Access Compliance Report Public Rights-of-Way (Curb Ramps)

Main Street: N/A Cross Street: ORTEGA_HWY Location: NE

ADA ID: RPRK211123122747 Ramp Type: Type 1 - Perpendicular Diagonal Initial Pass/Fail: Pass Overall Compliance: No Severity Score: 5

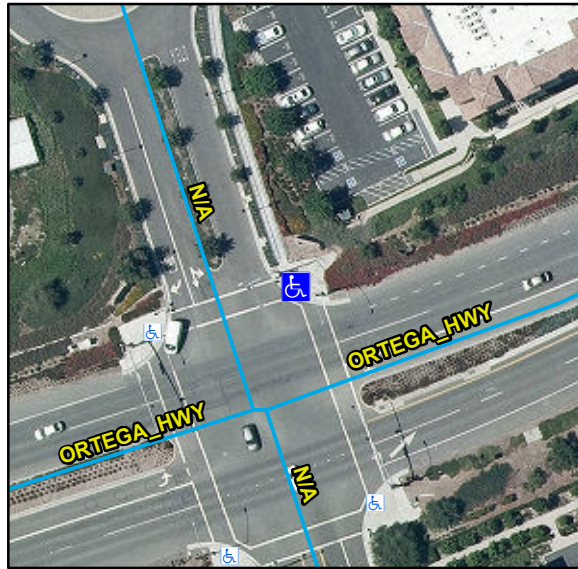
Yes	Ramp Inside Crosswalk 1	Yes	Yes	Ramp Inside Crosswalk 2	Yes
	Crossing 1 Slope (%)	0.8		Crossing 2 Slope (%)	11.1
	Crossing 1 Cross Slope (%)	4.6		Crossing 2 Cross Slope (%)	4.7
Yes	Gutter Ponding	No	No	Curb Slope	7
Yes	Gutter Lip Height (in)	0		Road Run Slope (%)	5.4
No	Gutter Run Slope (%)	5.5		Road Cross Slope (%)	0.9
No	Gutter Cross Slope (%)	5.3			
Yes	Overall Surface Condition: Acceptable		Yes	Perp Joint Present	Yes
	Cross Gutter Present?	No		Spandrel Present?	No
	Replace Cross Gutter?	N/A		Replace Spandrel?	N/A

Remove & Replace Curb Slope. Remove & Replace Gutter.
